Service Bulletin No. 384

MODEL	TYPE	SECTION/GROUP	DATE
D Series Coaches	Field Change Program	7 – Electrical	
SUBJECT			
SEDAN ENTRANCE DOOR LOGIC ON ACTIA MULTIPLEX EQUIPPED COACHES			
CONDITIONS

Ref. NHTSA Recall No.: 12V–086

Figure 1. Program Rev. Level decal located on the front junction box frame.

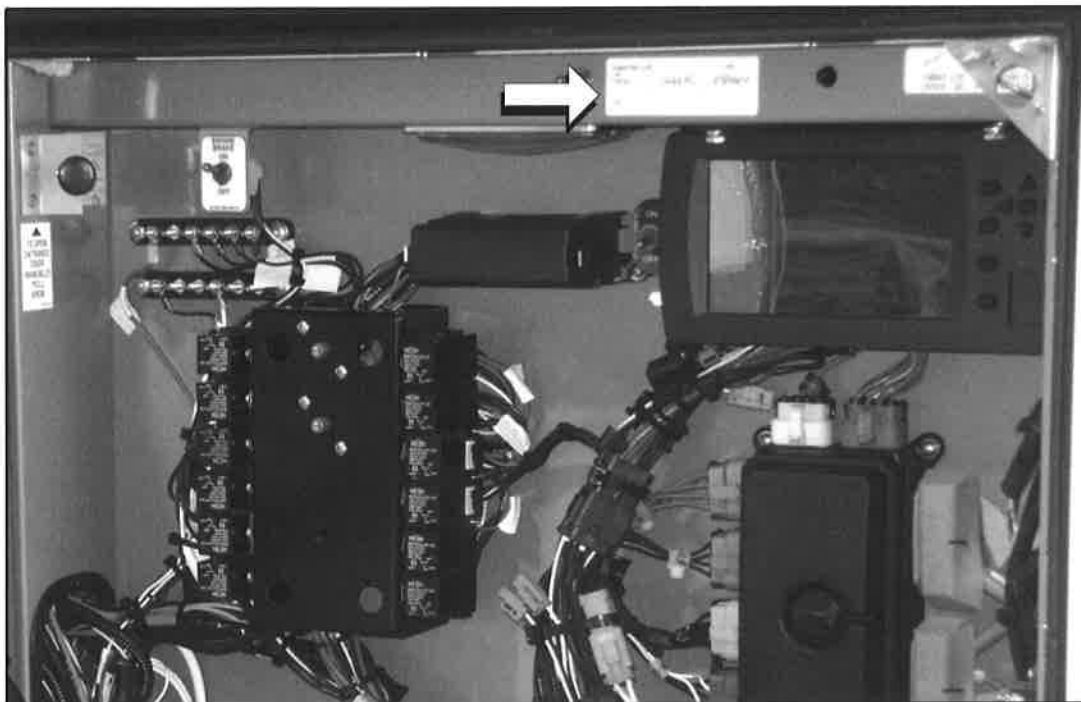
1. Position the rotary dial on the lower, LH console switch panel to ENGINE STOP. Ensure the main battery disconnect switch is in the ON position.
2. Connect the laptop to the coach, equipped with Amp reflash software, and download the new control logic.
3. Open the front junction box door. Locate the Program Rev. Level decal in the upper, RH corner (refer to Figure 1).
4. Using a marker or pen, clearly print to update the Program Rev. Level decal by recording the new control logic revision level and the date the download occurred on the applicable line of the decal.
